Mayberry, Colorado Springs

Filing No. 3

Construction Drawings

MAYBERRY, COLORADO SPRINGS - FILING NO. 3

TITLE SHEET

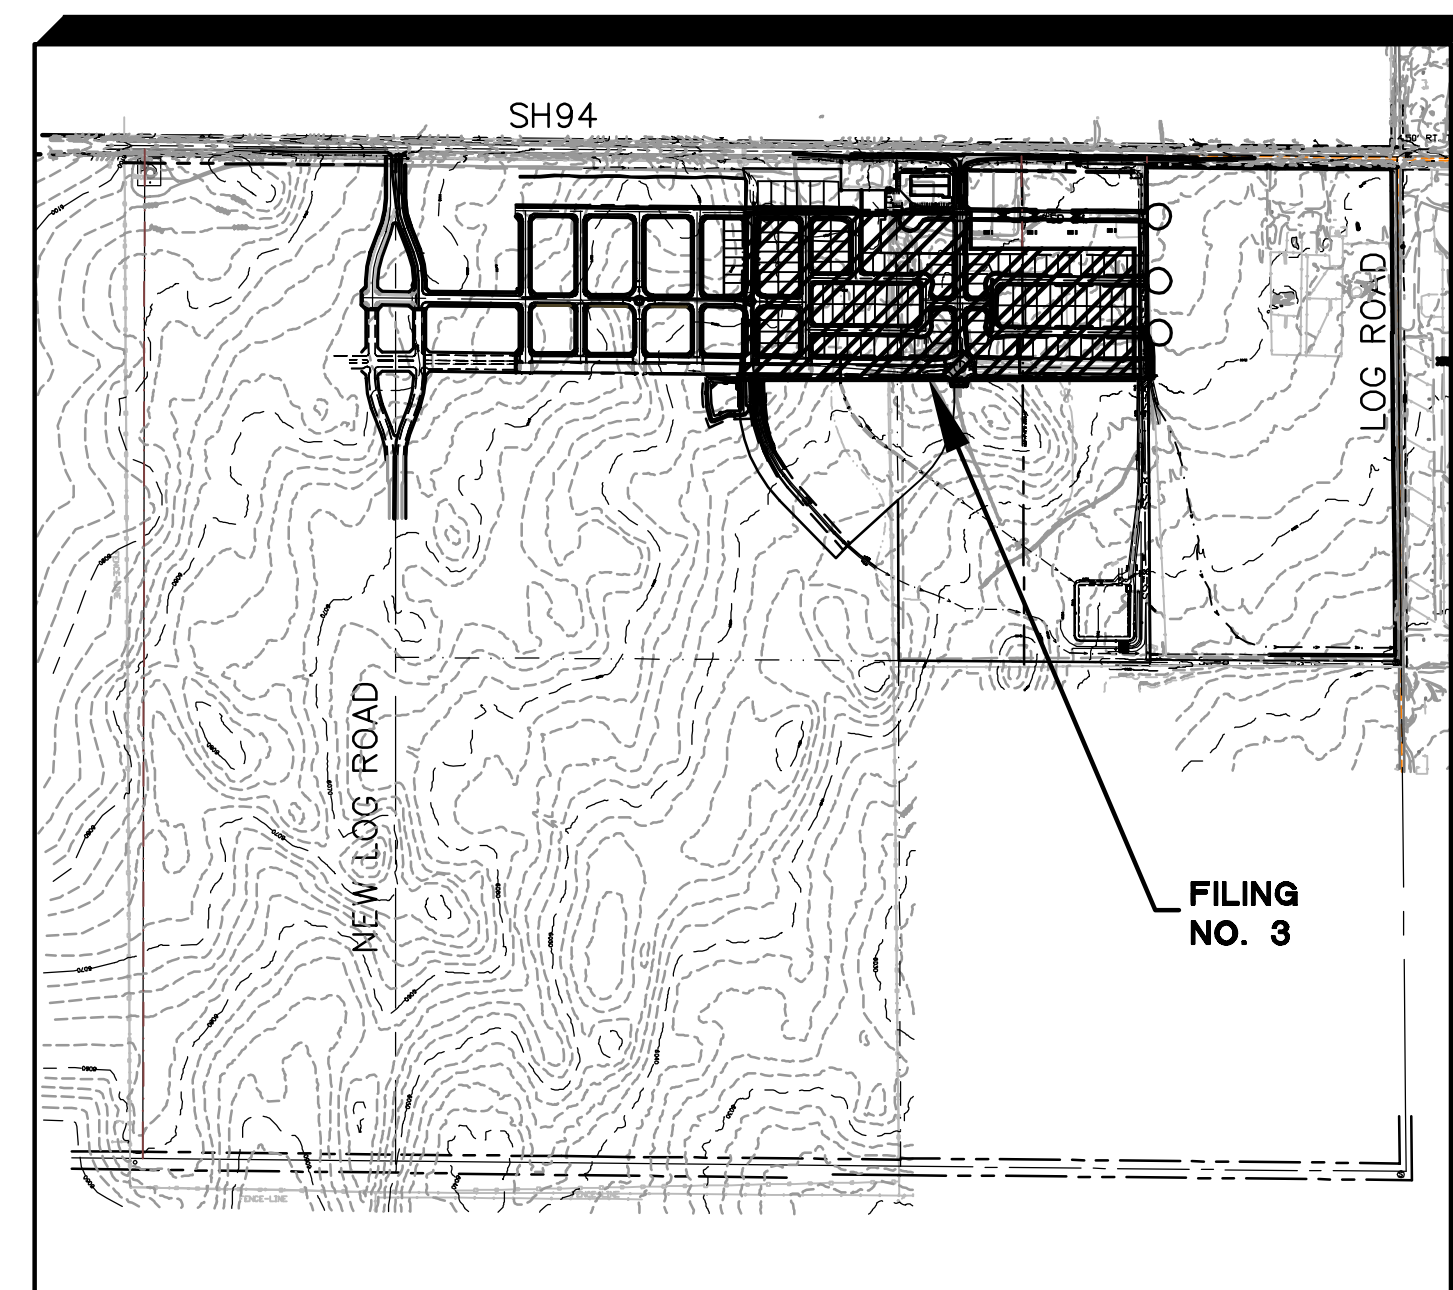
Please add PCD File
No. SF-2219

Please replace with the following text:
"These detailed plans and specifications were prepared under my direction and supervision. Said plans and specifications have been prepared according to the criteria established by the County for detailed roadway, drainage, grading and erosion control plans and specifications, and said plans and specifications are in conformity with applicable master drainage plans and master transportation plans. Said plans and specifications meet the purposes for which the particular roadway and drainage facilities are designed and are correct to the best of my knowledge and belief. I accept responsibility for any liability caused by any negligent acts, errors or omissions on my part in preparation of these detailed plans and specifications."

Replace with the following:
"I, the owner/developer have read and will comply with the requirements of the grading and erosion control plan and all of the requirements specified in these detailed plans and specifications."

GENERAL NOTES & LEGEND

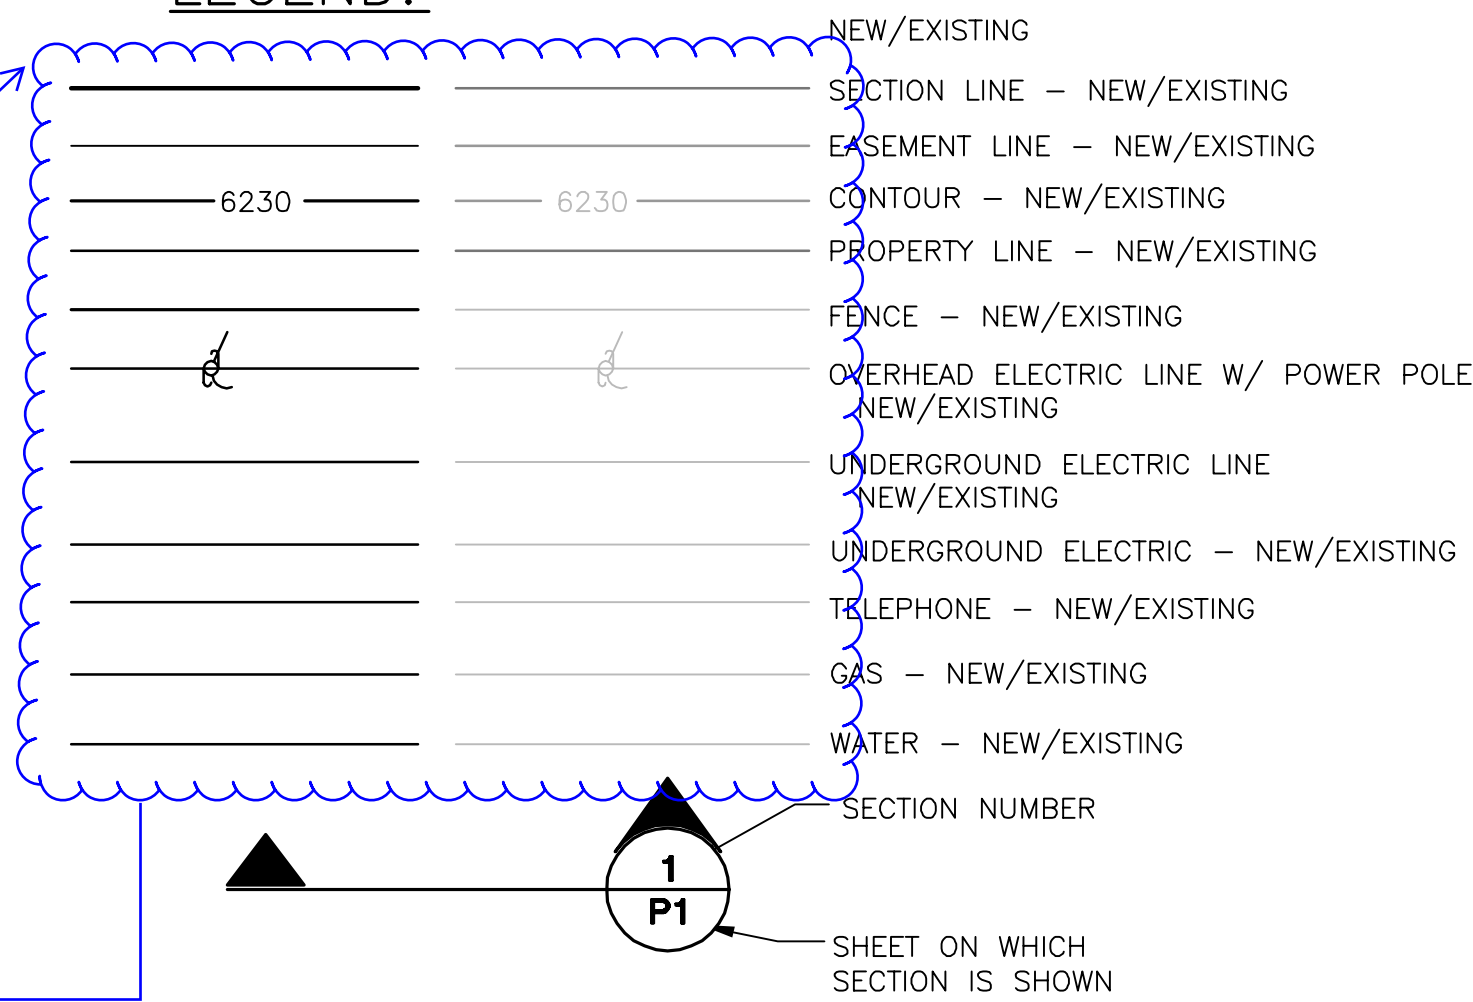
Please update this note as the PUDSP recently approved was per the latest version of the ECM at the time of the approval

Please add to the legend a linestyle to differentiate between the different filings. It is hard to see where the limits of filing 3 are.

It appears that there is missing text/labels for each of the items such as WT for water lines shown on the plans. Also all the line types are the same on the legend and do not match the plans. Please update accordingly.

fyi, 25 ft. appears to be provided at all local roadway intersections

**MASTER
UTILITY PLAN**

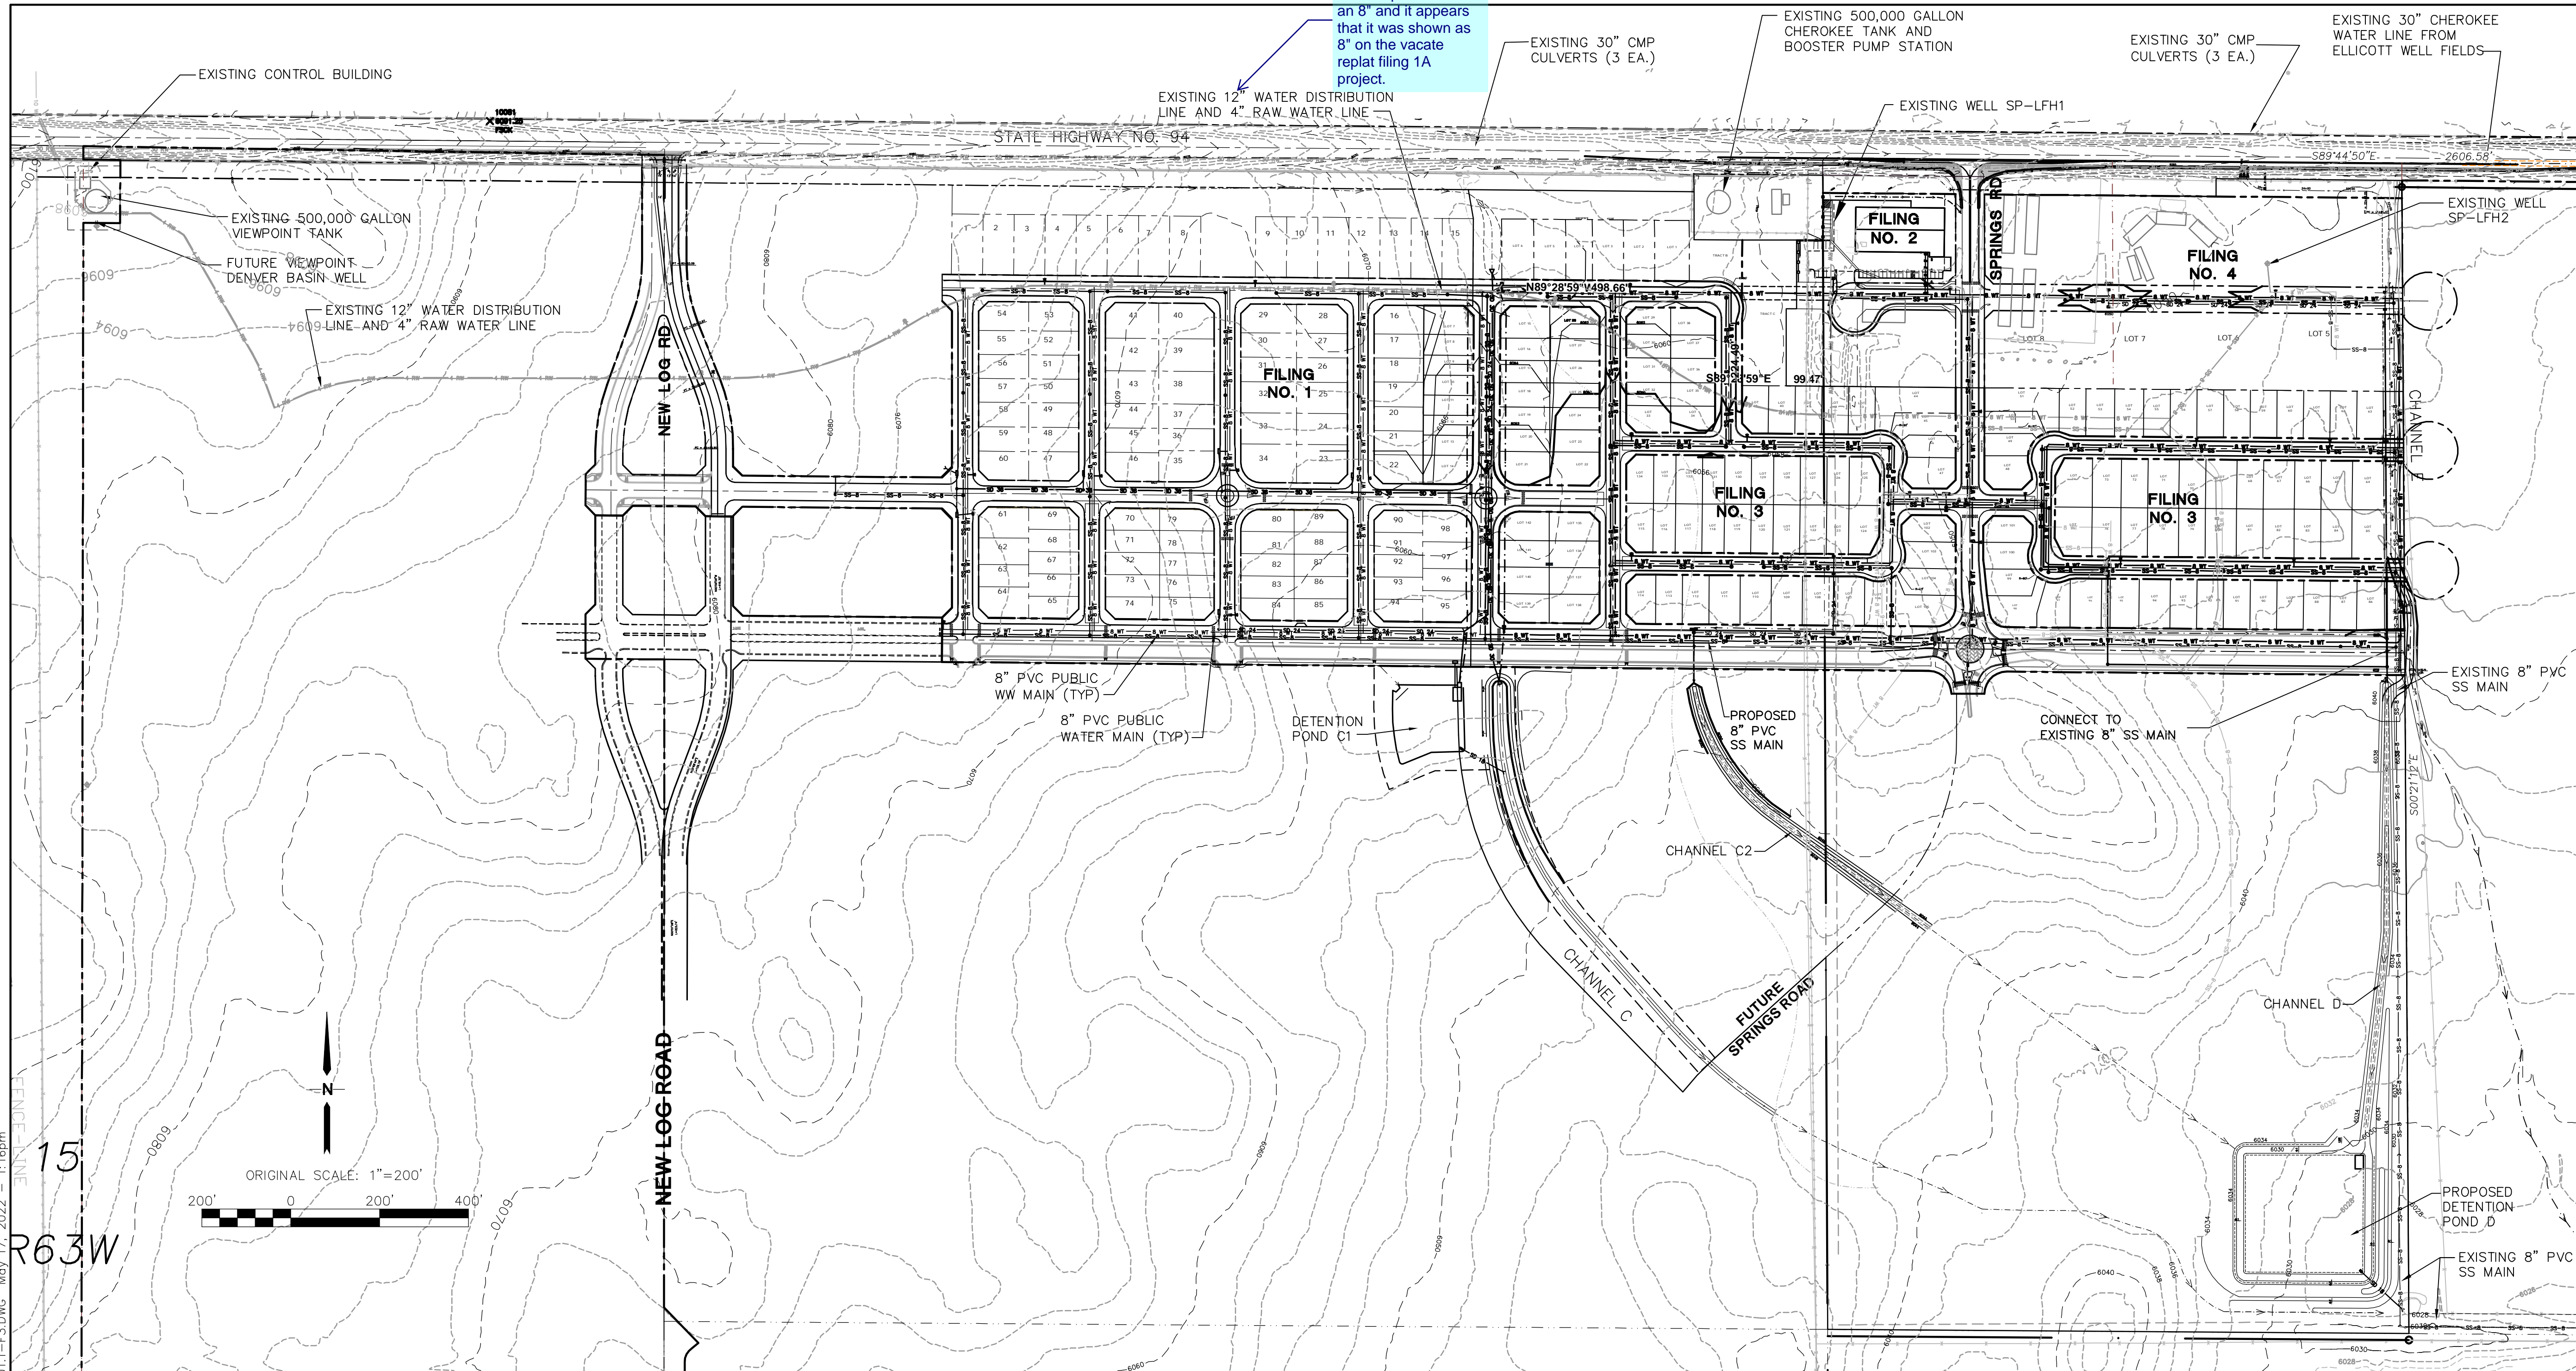
Please verify if this is 8" or 12", it appears that the plans indicate an 8" and it appears that it was shown as 8" on the vacate replat filing 1A project.

PHASE 2 UTILITY PLAN

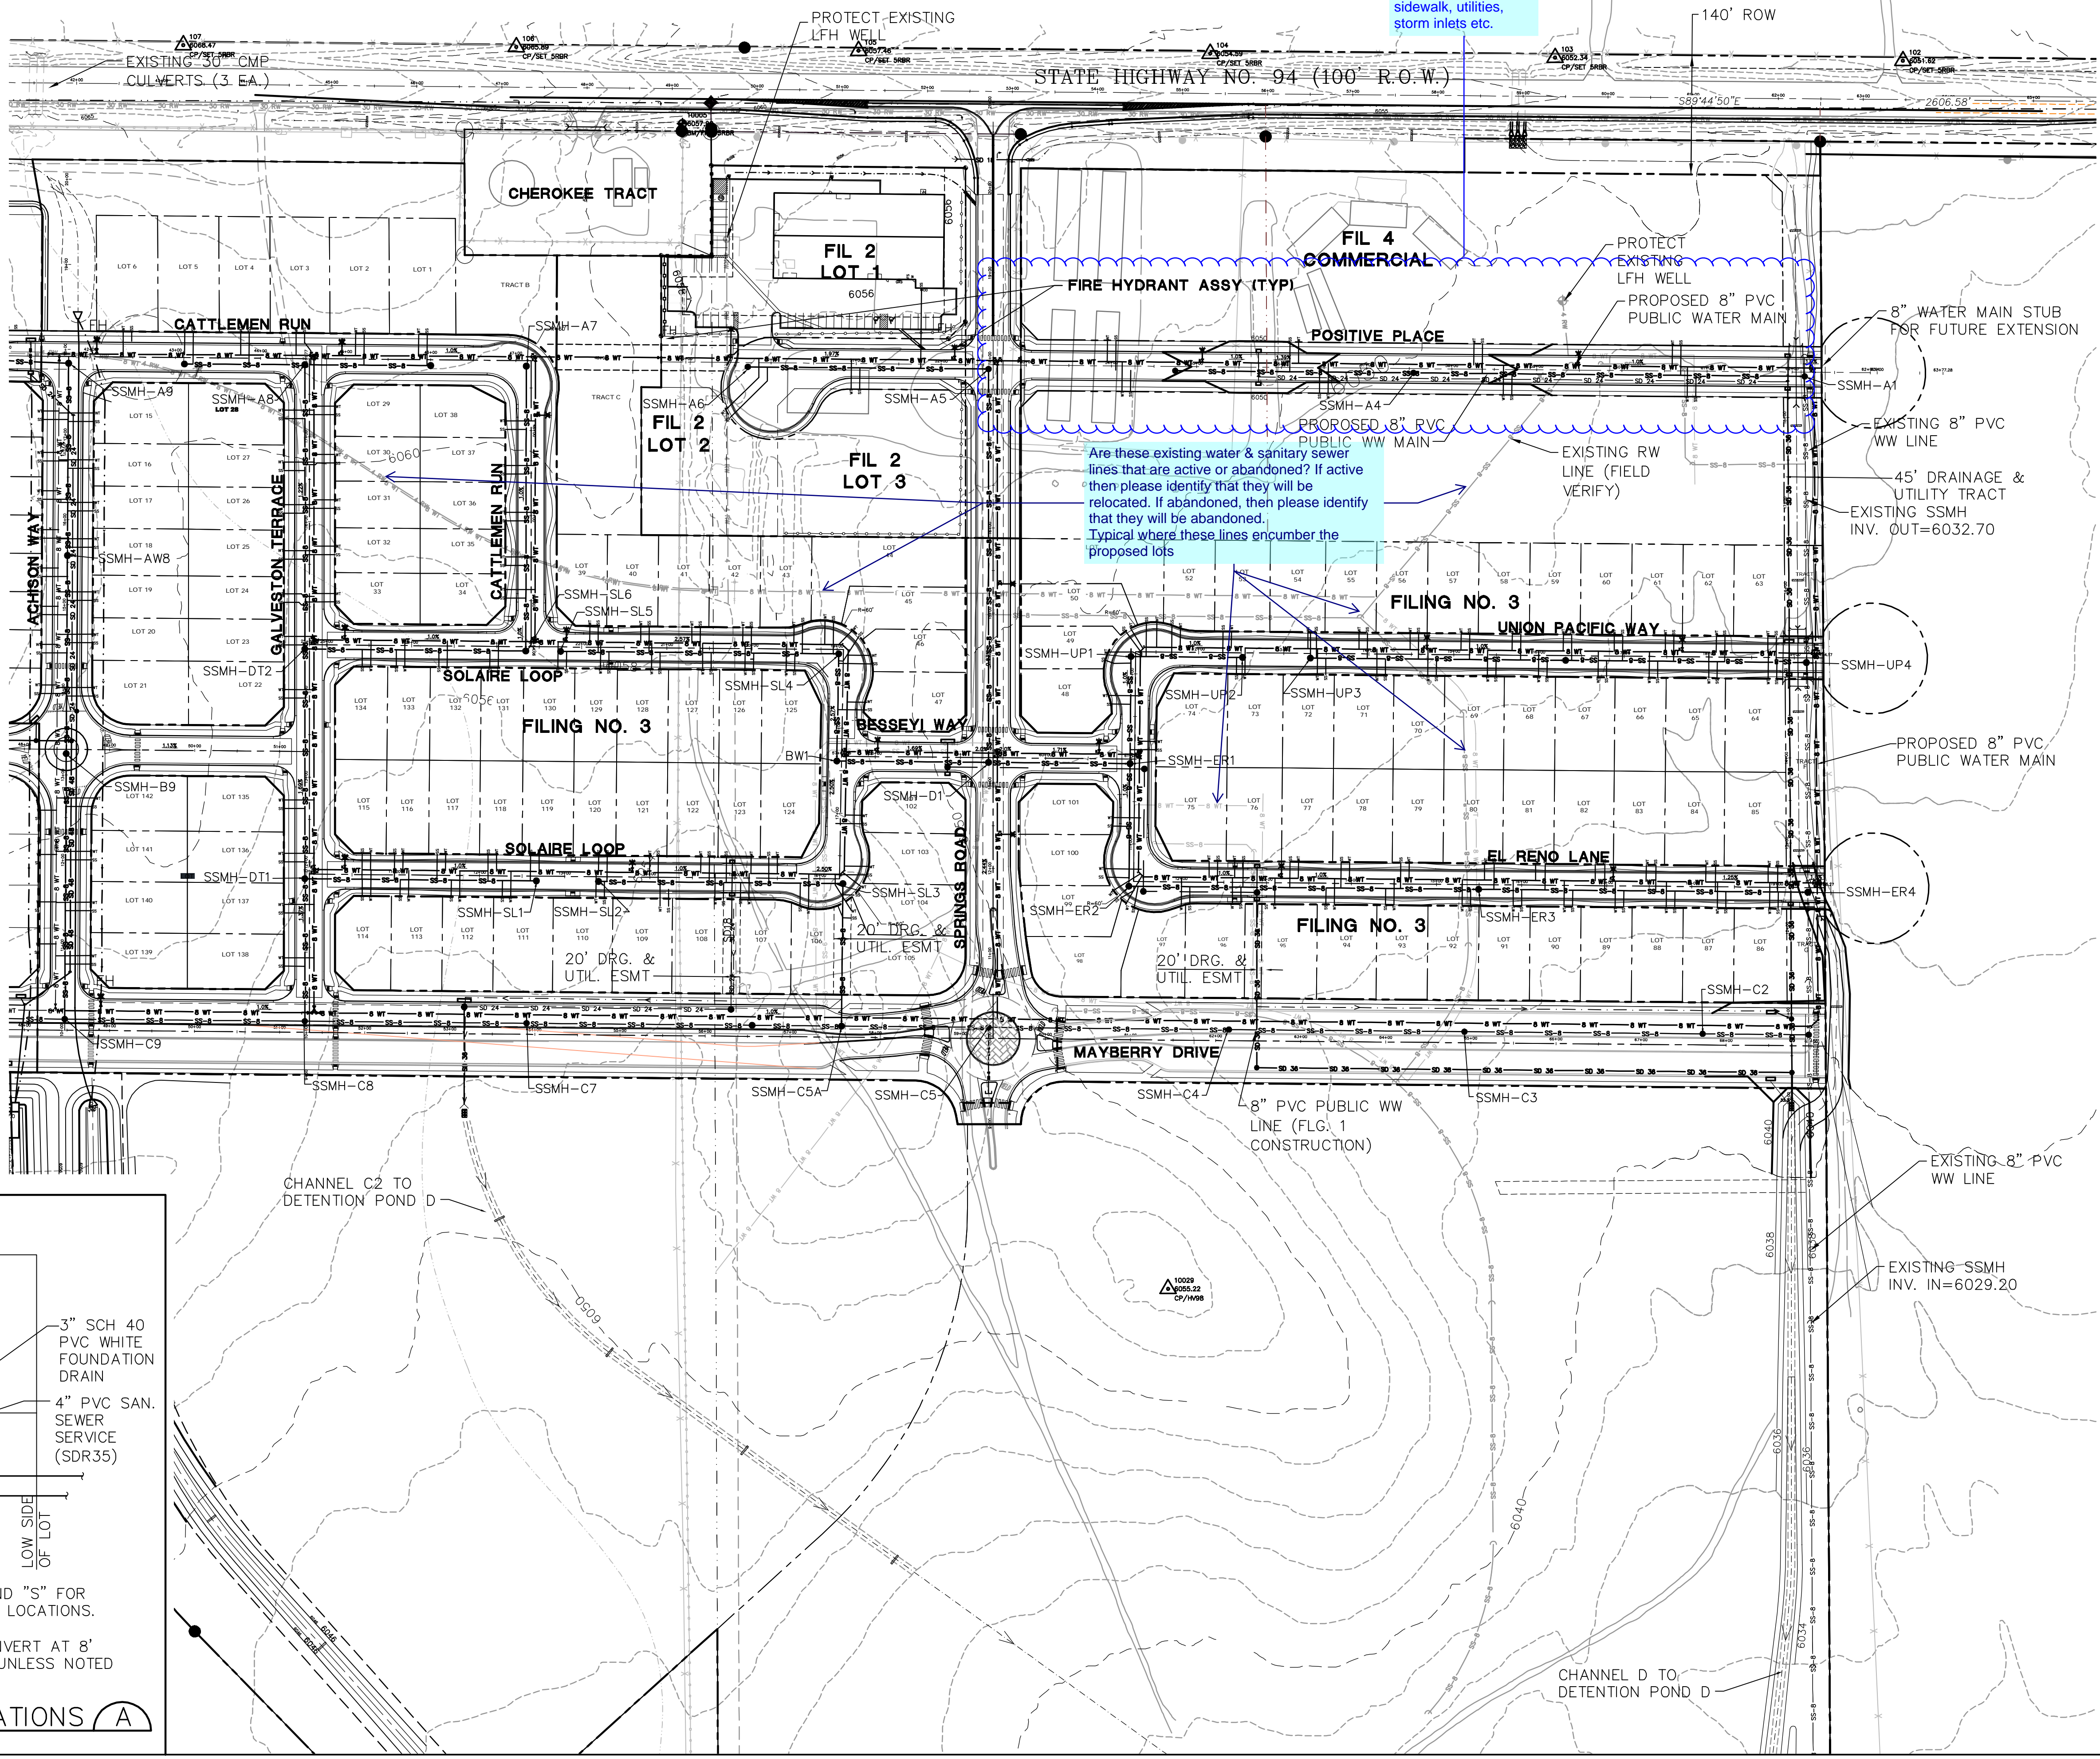
Please remove items that are to be constructed in the future filing 4 such as Positive place grading, C&G, sidewalk, utilities, storm inlets etc.
